RC4: 'Reply on RC3', Norman Donaldson, 10 Dec 2025

Review of "Monitoring and quantifying wind turbine clutter in DWD weather radar measurements"

Author(s): Michael Frech et al. (michael.frech@dwd.de)

MS No.: egusphere-2025-4957

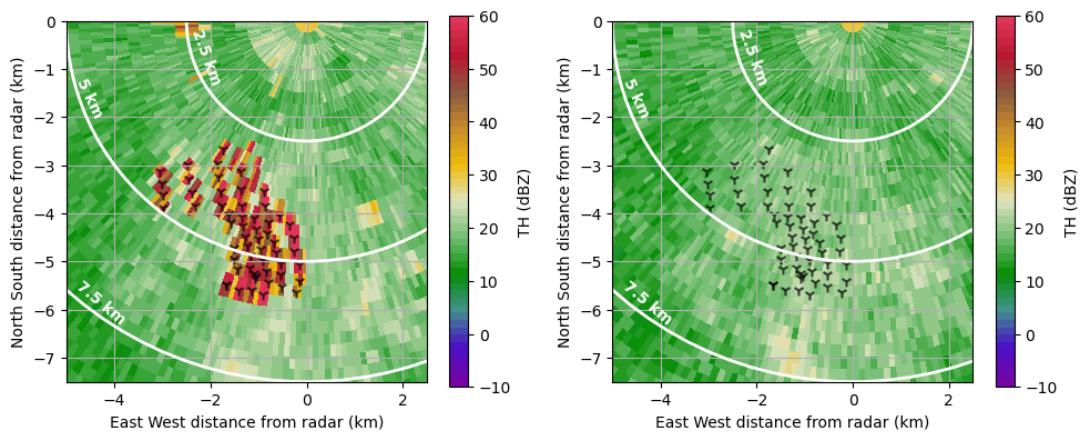
- **Figure 10:** In my opinion the upper limit on reflectivity colours should be higher. I was surprised that the turbines seemed to be spread uniformly across 3° , until I realized that the observed values were far above the colour limits; colours were saturated so no detail below 3° in azimuth. I suspect the reported reflectivities are in excess of 50 or 60 dBZ. (This links back to the remarks around line 45 but isn't really a topic for discussion in the paper.)

- **Response:** You are correct, the colours are saturated at the location of the wind turbines. Setting the range of the color bar to a range of -10dBZ to 60 dBZ (see plot below) shows this. The point that we want to convey with this figure is to show how the bins surrounding the wind farm are or aren't affected by the turbines, not so much the impact at the location of the turbines itself. Hence, we opted to use a narrower color bar range to focus on more subtle differences. Figure 13 actually contains data from the exact same time with an extended colorbar.
